**CITY OF ROCKVILLE PLANNING DIVISION
STAFF REPORT**

Detailed Application CPD2000-0004C for
Comprehensive Planned Development
CPD1999-0004, Fallsgrove

Proposed Pump Station Location

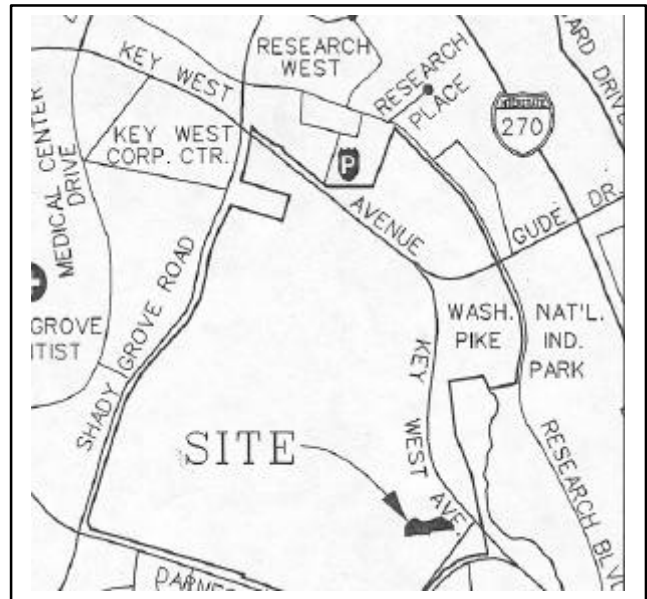
The applicant seeks detailed (final) approval for a pump station to facilitate development on the Fallsgrove site. This application encompasses approximately 1.23 acres generally in the area of Darnestown Road and West Montgomery Avenue.
